# Omaha Public Power District

August 31, 1981

Reference: Docket No. 50-285

The Commission's letter dated May 13, 1981, requested additional information regarding the adequacy of Fort Calhoun Station's electrical distribution system voltages. The District's submittal dated July 2, 1981, provided responses to Questions A, B, and C of the Commission's letter, while responses to Questions D and E were to be provided at a later date. The District's response to Questions D and E is attached.

Motor Terminal Voltage  
Calculations

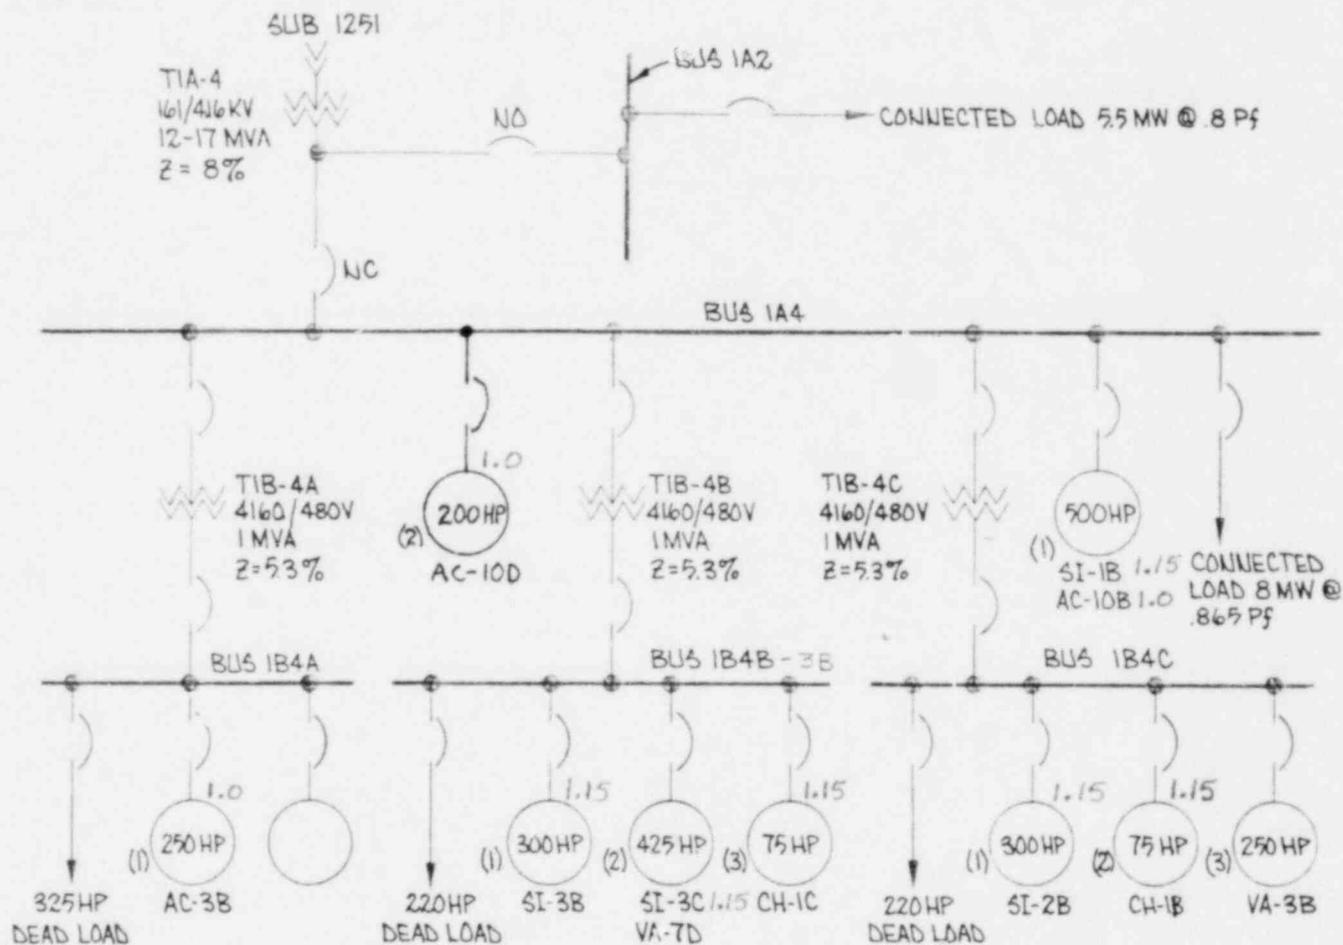
What is the service factor for the 4160V, 4000V and the 460V safeguards motors?

Enclosure 1 provides a complete listing of motor service factors (except for ventilation air fan motors VA-3A, VA-3B, VA-7C, and VA-7D) for the 4160V, 4000V, and 460V safeguards motors. Custom built, high efficiency motors such as VA-3A, VA-3B, VA-7C, and VA-7D are manufactured without motor service factors because they are designed and used for a specific function.

*Service Factors in green.*
